**Re: Defect Information Report – Supplemental Report No. 3
11V-160, FL-592, Business Class M2 Headlight Height
Dealer Notification**

Subject: Business Class M2 Headlight Height

Models Affected: Specific Freightliner Business Class M2 vehicles manufactured July 19, 2010, through January 14, 2011.

Fig. 1, Headlight Measurement

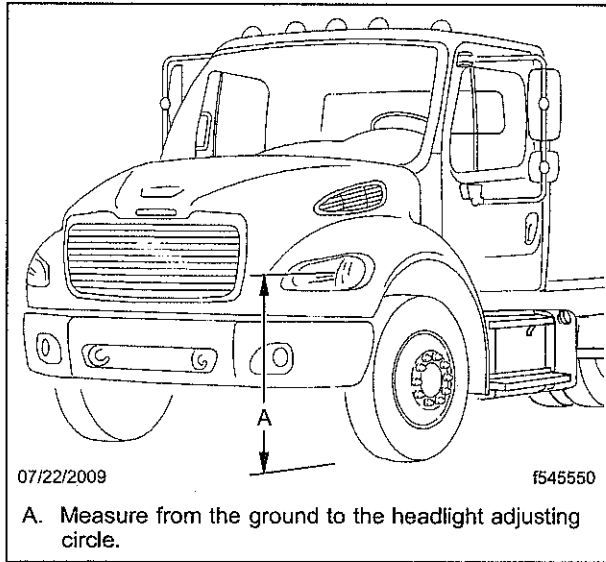
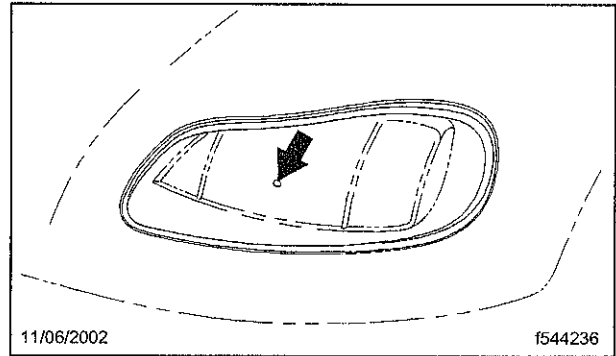
- 3.2 Measure from the ground to the center of the highest headlight lens. See **Fig. 1** and **Fig. 2**. If this height is 54 inches (137 cm) or less, nothing more needs to be done. Clean a spot on the base label (Form WAR259) and attach a completion sticker for FL592 (Form WAR260) to the base label.

16. Install the mounting capscrews.
17. Install the headlight cover.
18. Close the hood.
19. Connect the batteries.
20. Check the height of the headlights. Measure from the ground to the center of the highest headlight lens. See **Fig. 1** and **Fig. 2**. The height should be 54 inches (137 cm) or less.

Fig. 6, Guide Line for the New Headlight Opening

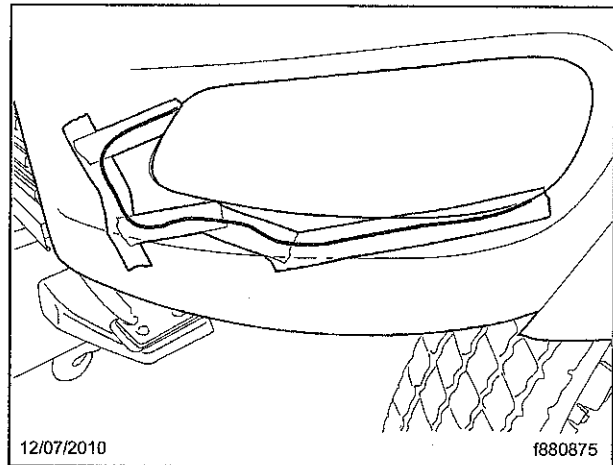
9. Draw an outline on the tape using the edge of the template on each side of the vehicle.
10. Remove the templates. The guide lines for the saw should be clearly visible. See **Fig. 6**.

Fig. 7, Cutting Along the Guide Line

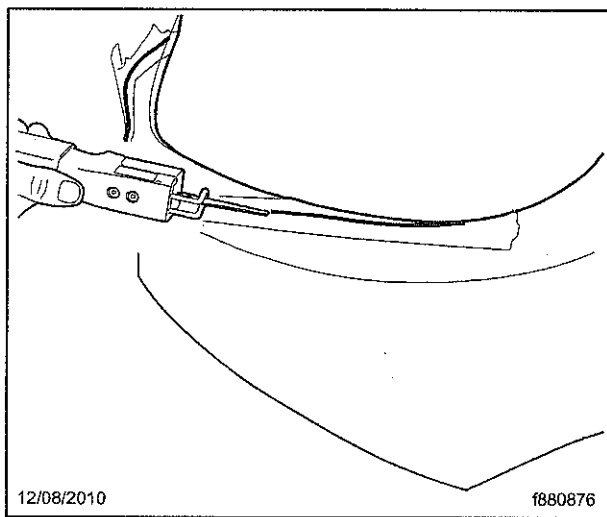
11. Using a metal saw, cut along the guide line. See **Fig. 7**. Use care to adjust the saw and cut around the casting and the wiring support bracket. Repeat on the other side of the vehicle. See **Fig. 8**.

Fig. 9, New Headlight Opening

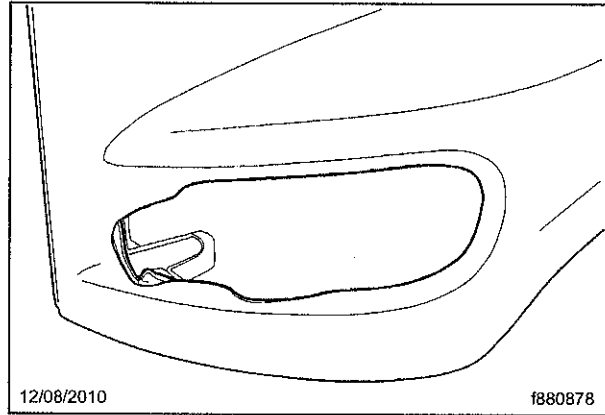
12. Remove the cut pieces of the headlight openings and remove any remaining tape. See **Fig. 9**.
13. Open the hood.
14. Install the new headlight assemblies. See **Fig. 10** and **Fig. 11**.
